Planning Commission Staff Report

Project Type: Site Development Plan

Description: **Spirit Energy, LLC (Starbucks):** A Site Development Plan, Landscape Plan, Lighting Plan, Architectural Elevations and an Architect's Statement of Design for a 0.31 acre tract of land zoned "PC" Planned Commercial District located in the southwest quadrant of the intersection of Olive Boulevard and Woods Mill Road

DT ORDER POINT CANOPY FREESTANDING

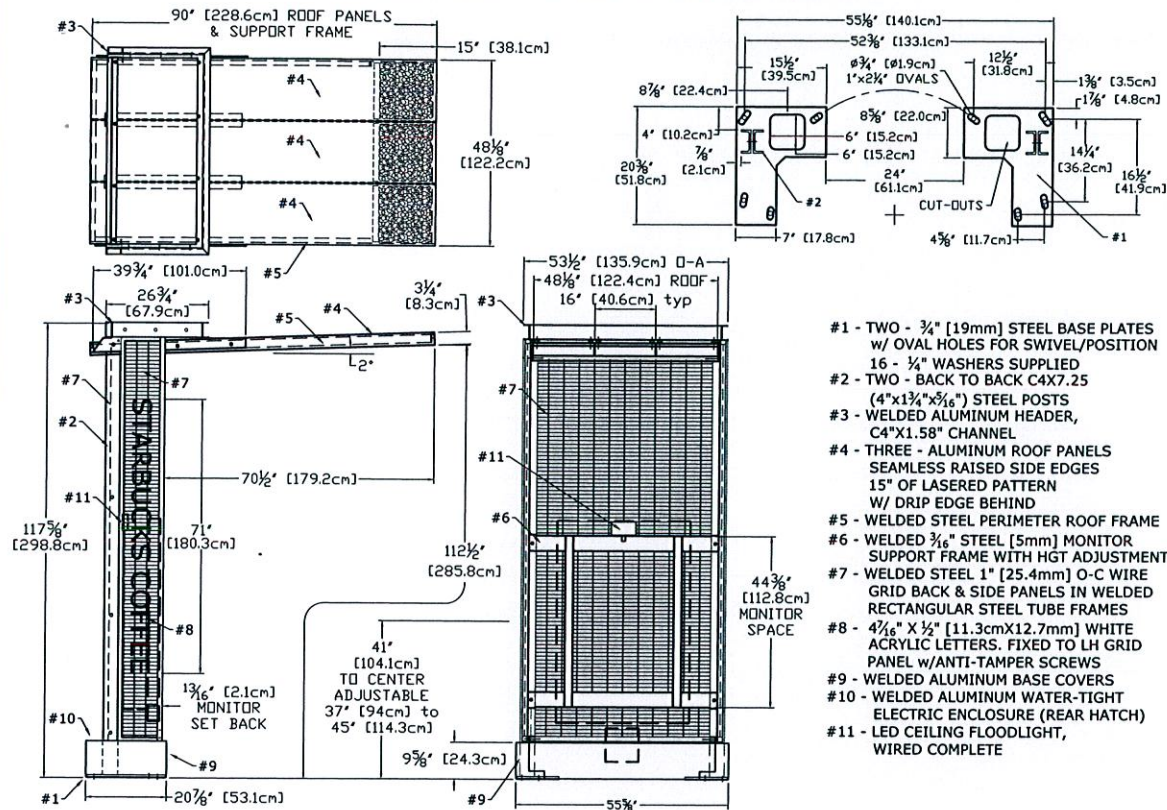
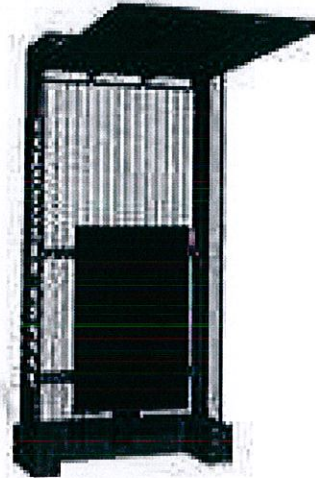
1. Staff to verify that the proposed order canopy design and materials are compatible with the building and meet all City requirements.
2. Review the railing design and other pedestrian control measures to ensure pedestrian safety.

In response to the ARB's recommendations, the Applicant has provided information regarding the order canopy for the Planning Commission packet. The order canopy is to be constructed of steel that is painted black in color, which is consistent with the black metal railing and black metal awnings utilized on the building.

DUMPSTER ENCLOSURE ELEVATIONS

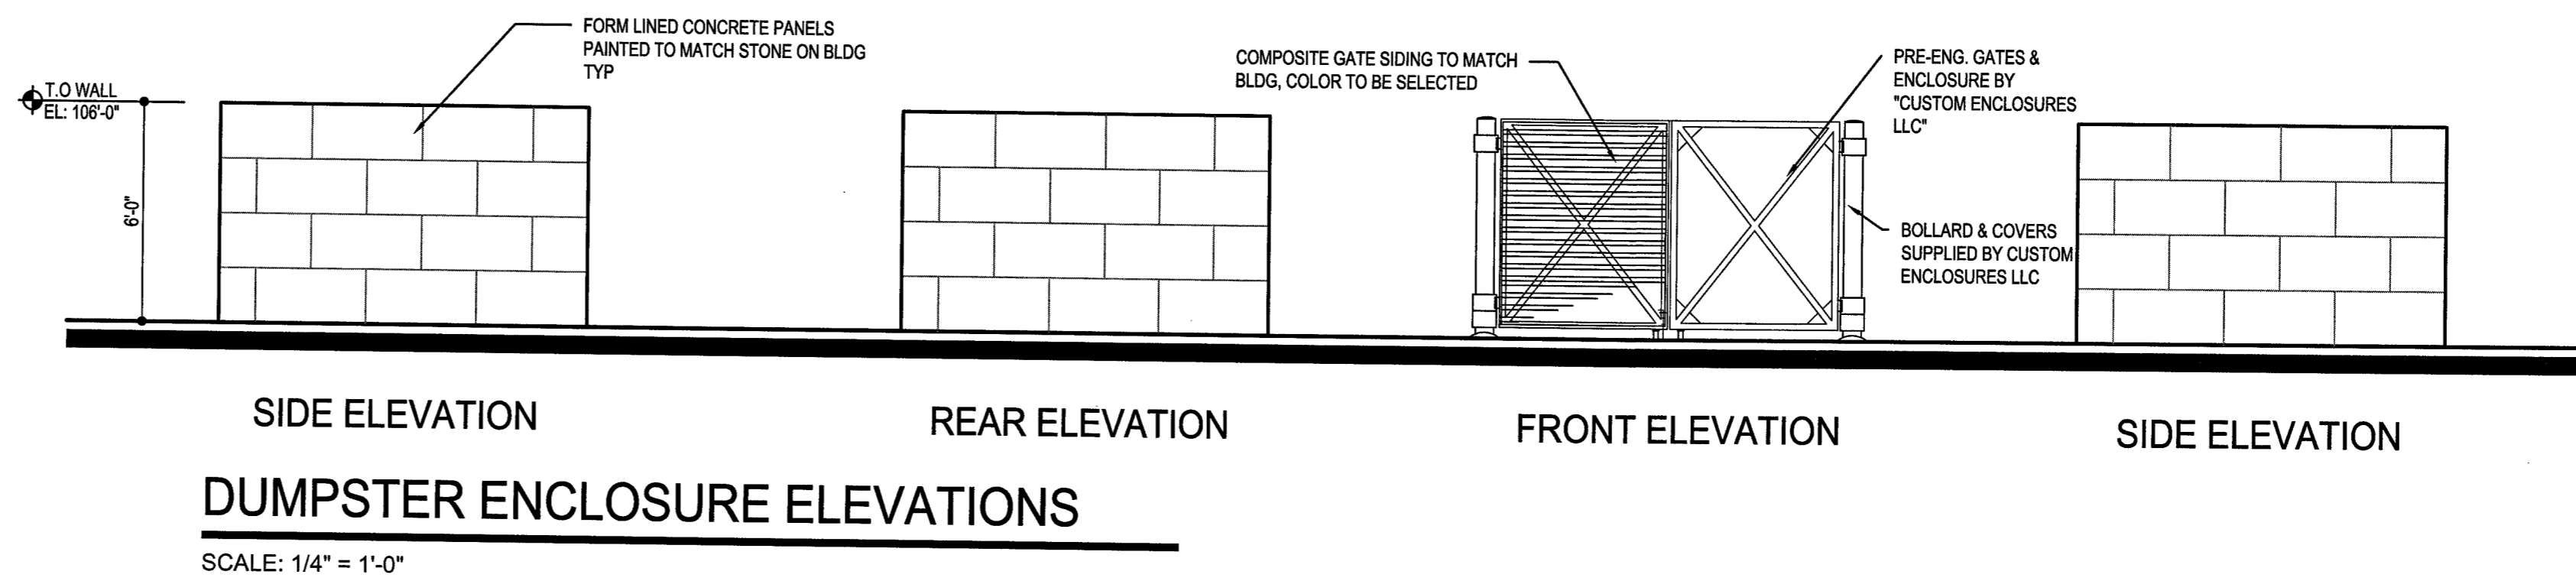
The dumpster enclosure is comprised of form lined concrete panel walls that will be painted to match the faux stone wainscot on the building. A gate constructed of composite siding will also match the building color. Regarding the dumpster enclosure, Ordinance 2592 includes the following specific requirement:

- *Trash enclosures: The location, material, and elevation of any trash enclosures will be as approved by the Planning Commission on the Site Development Plan. All exterior trash areas will be enclosed with a six (6) foot high sight-proof enclosure complemented by adequate landscaping approved by the City of Chesterfield on the Site Development Plan.*

Accordingly, a detail of all four dumpster elevations is included in the review packet and landscaping is proposed along three sides of the dumpster, as shown on the landscape plan.
